Re: Donald & Gretchen Steere property (formerly Timothy Friel property), Sand Piper Road
(Map 85, Lot M-6), Peaks Island, Portland

SUBJECT: Friel property, Sandpiper Road, Peaks Island

Replacement System Variance Request

SUBSURFACE WASTEWATER DISPOSAL SYSTEM APPLICATION

SUBSURFACE WASTEWATER DISPOSAL PLAN

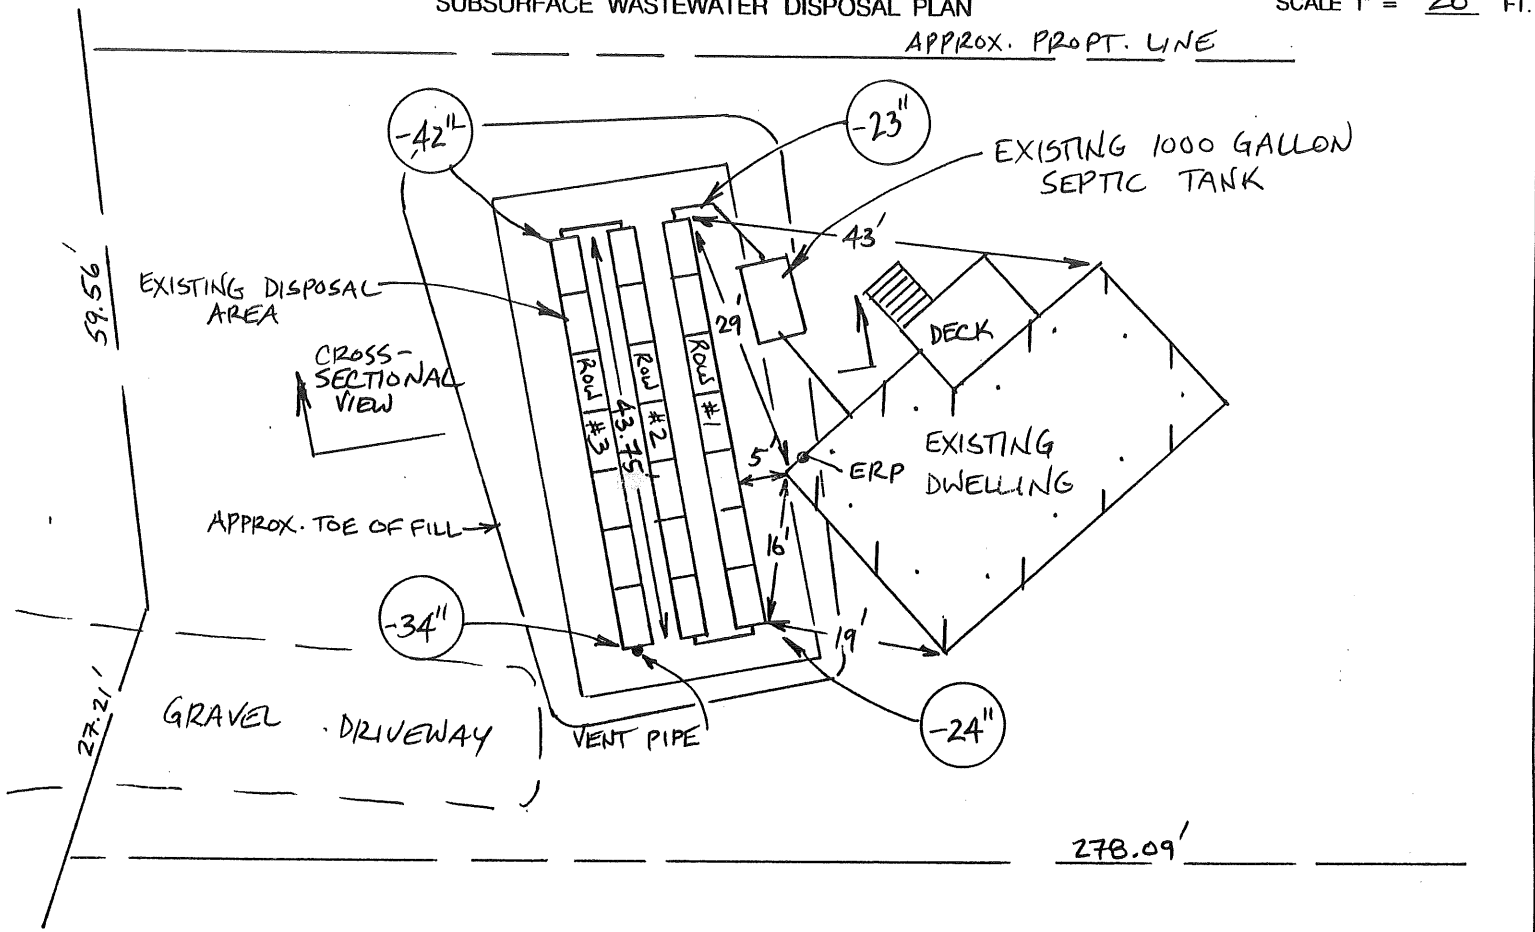
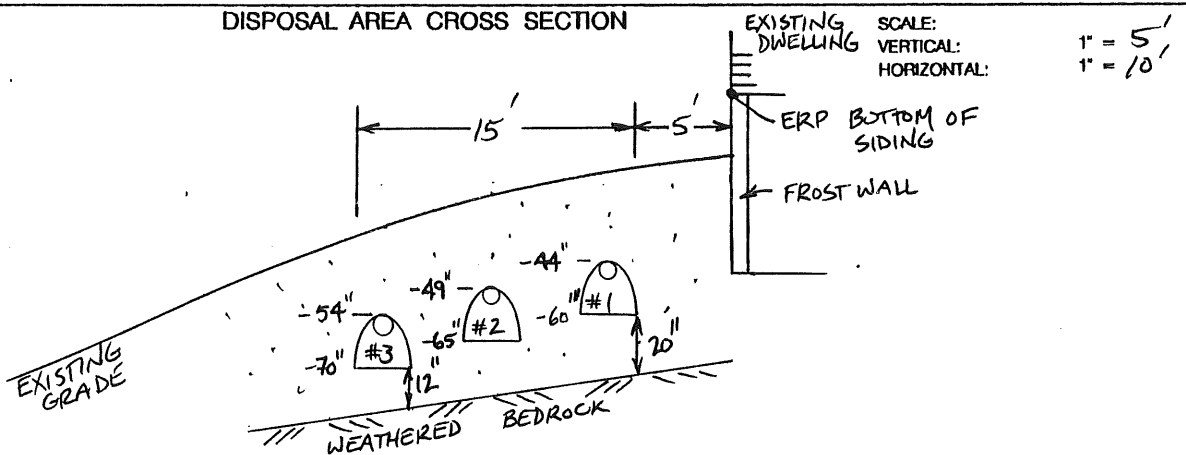
The Division has received a Replacement System Variance Request for an After-the-Fact variance for the subject property. The request is to allow the existing system to continue to be utilized although the setback distance from the structure is 5 feet rather than the required 15 feet and the vertical separation at the first row of chambers is 12 inches to bedrock rather than the required 24 inches. The variance was submitted as a replacement system variance as the system is in place, and has been in place since 1992. The original installation was a New System.

As stated in the Division's letter dated 2/9/99, although the system was inspected and approved by the City of Portland's Local Plumbing Inspector at the time of installation, the Division found the installation of the septic system to be in violation of the Rules. Therefore, in accordance with the "possible options to resolve this issue" as stated in that letter, Matt Logan of Albert Frick Associates re-visited the site. His findings were that due to the slope of the property, Option 1 - moving the uppermost row of chambers to the lower area of the system - was not feasible. He then moved on to Option 2 - backhoe determination of the separation distance between the bedrock and the bottom of the chambers. He found that the uppermost row of chambers (the row which is 5 feet from the structure) had a separation distance of 12 inches to bedrock. The other rows had upwards to 23" to bedrock. Therefore, an After-the-Fact Variance Request was made for the reduction in vertical separation to bedrock and reduction in separation distance to the structure.

Based on the site work performed by Matt Logan, the basis that the structure and the system have been in use since 1992, and that Mr. Logan did not find any signs of system failure, the Division approves the After-the-Fact Variance Request.

This approval does not imply that the Division condones the installation and approval of a system which is contradictory to the system design and in conflict with the Rules.

Because of the non-conforming installation, the Division makes no representation or guarantee as to the efficiency and/or operation of the system, particularly to the respect to groundwater contamination in the bedrock.
